Access Compliance Report

Public Rights-of-Way

Intersection ID: 20540	Main Street: FAIRVIEW_RD	Cross Street: VALENCIA_TR	Location: NW
ADA ID: 6C3F146A4A7A	Ramp Type: Perp	Initial Pass/Fail: Fail	Overall Compliance: No
Severity Score: 13.75			
Codes/Mitigation Info/Possible Solution		Field Measurements/Component Compliance

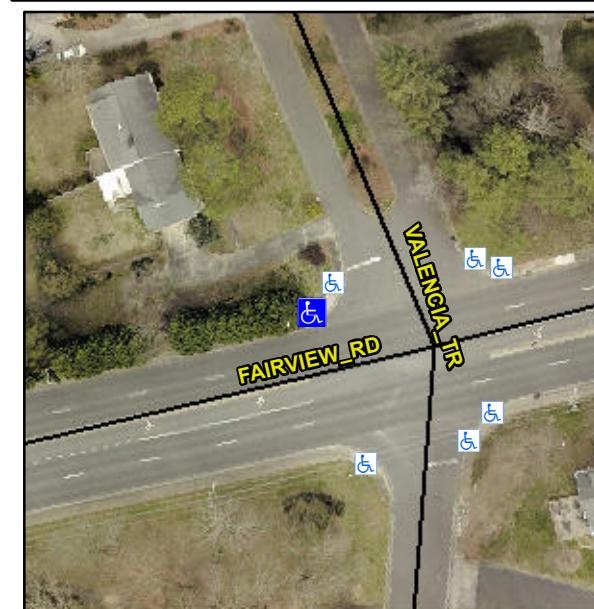
Not Found, R304.2.2, R304.5.3

Compliance	Description	Data	Compliance	Description	Data
N/A	Ramp Length (in)	57.0	No	Ramp Slope (%)	8.7
Yes	Ramp Width (in)	48.0	No	Ramp XSlope (%)	4.7
N/A	Flare Type LT	N/A	N/A	Flare Type RT	N/A
N/A	Flare Slope LT (%)	N/A	N/A	Flare Slope RT (%)	N/A
N/A	Flare Traversable LT?	N/A	N/A	Flare Traversable RT?	N/A
N/A	Landing Length (in)	N/A	N/A	DWS Provided?	N/A
N/A	Landing Width (in)	N/A	N/A	DWS Contrast?	N/A
N/A	Landing Slope (%)	N/A	N/A	DWS Length (in)	N/A
N/A	Landing X Slope (%)	N/A	N/A	DWS Full Width?	N/A
N/A	Landing Curb? (Y/N)	N/A	N/A	DWS Offset (in)	N/A
N/A	Shared Landing?	N/A			
N/A	Gutter Ponding?	N/A	N/A	Gutter Slope (%)	N/A
N/A	Gutter Lip Ht (in)	N/A	N/A	Gutter X Slope (%)	N/A
N/A	Painted X Walk1?	No	N/A	Painted X Walk2?	N/A
	X Walk 1 Direction	To SE		X Walk 2 Direction	N/A
N/A	X Walk 1 Width (in)	N/A	N/A	X Walk 2 Width (in)	N/A
	X Walk 1 Slope (%)	3.8		X Walk 2 Slope (%)	N/A
	X Walk 1 X Slope (%)	2.6		X Walk 2 X Slope (%)	N/A

Remove & Replace Entire Ramp.
